Plot D Great Jackson Street Manchester M15 4NP - 137227/FO/2023

I have viewed the site plan and the arboricultural impact assessment, and we have a few concerns.

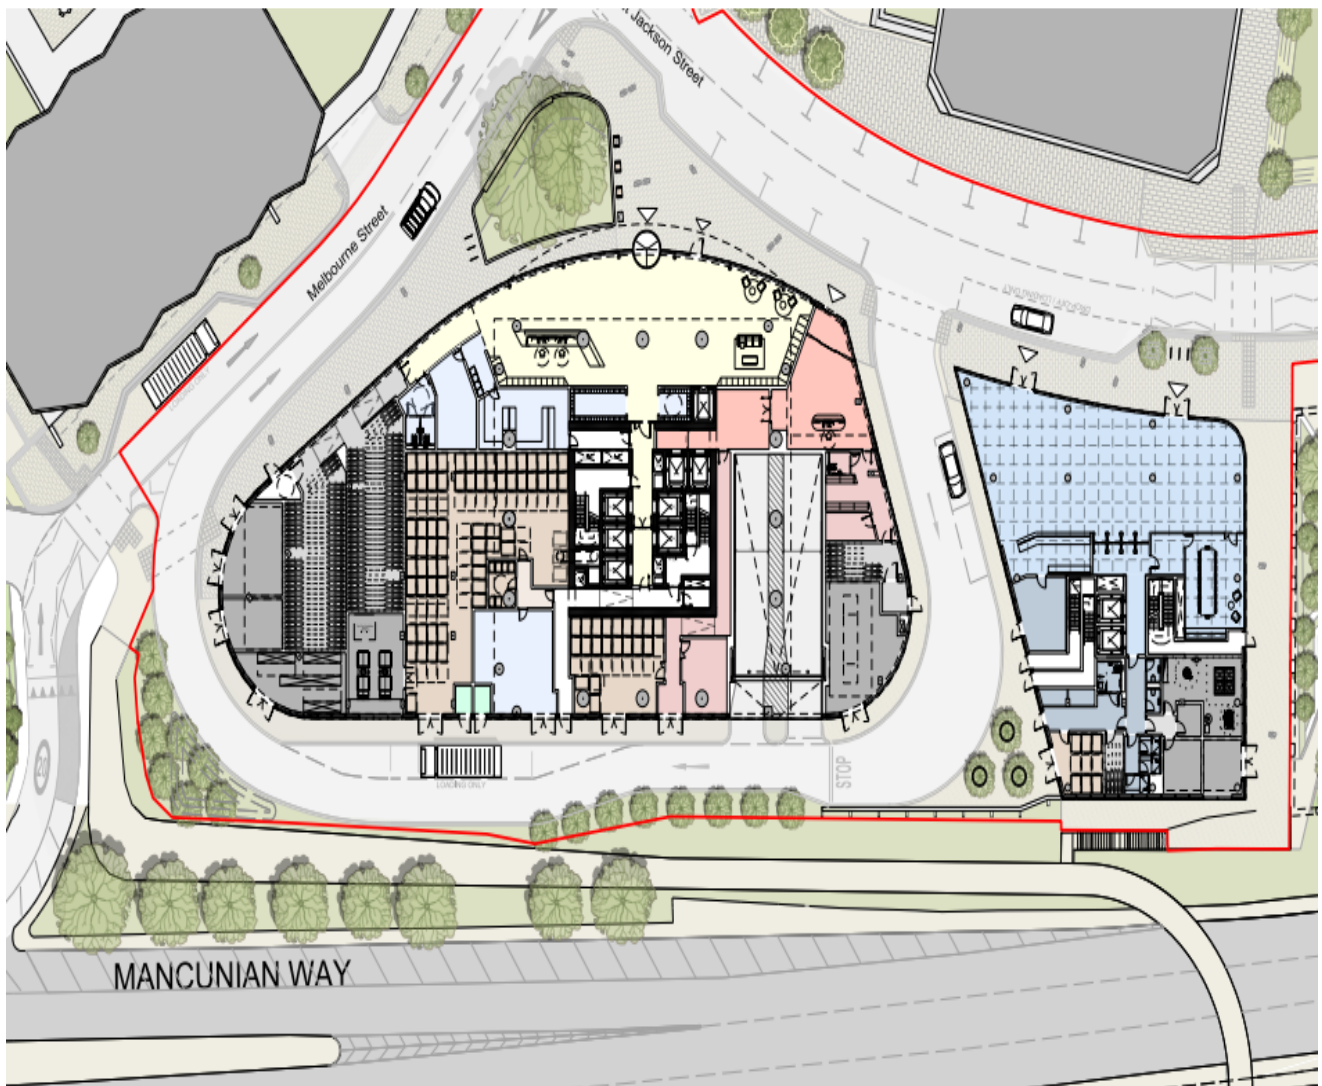
The proposed development will require the loss of 1 x Cat A tree and several Cat B trees within a city center ward and whilst there is no official policy, any tree removal proposals in the city center are expected to have a mitigation proposal of 3 trees for every tree removed, however, my apologies if I have overlooked the landscaping proposal but I was unable to locate the document. In addition to the landscaping proposal document, I was unable to locate any Biodiversity net gain document for this site.

It is unlikely that we would support this application from an arboricultural perspective without a detailed mitigation planting plan with a sufficient number of trees.

Section 3.3.1 in the screenshot below, mentions mitigation planting scheme, which I was unable to locate.
